Rezoning Transportation Analysis
Petition Number: Insert Zoning Petition #2022-030
General Location Identifier: 08311127

Revision Log:	Date	Description
	07-24-2022	First Review (AO)

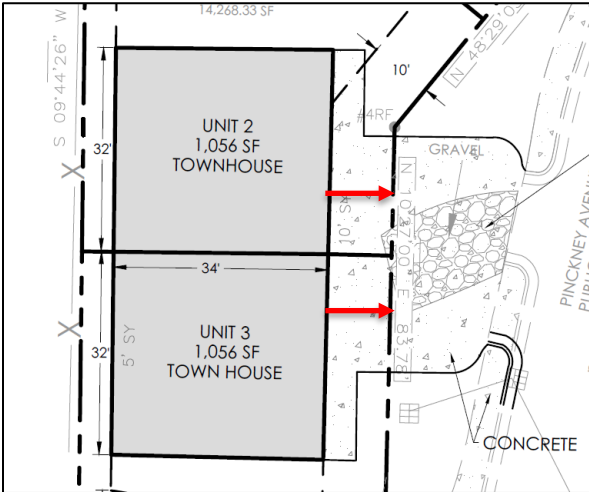
1. **Curblines:** The proposed zoning district has a setback measured from back of the existing or proposed future curblines.
 - a. **Matheson Avenue:** Curb and gutter to be 27-feet measured from centerline to back of curb .

Label and dimension the curb and gutter from the centerline for each road on the site plan.
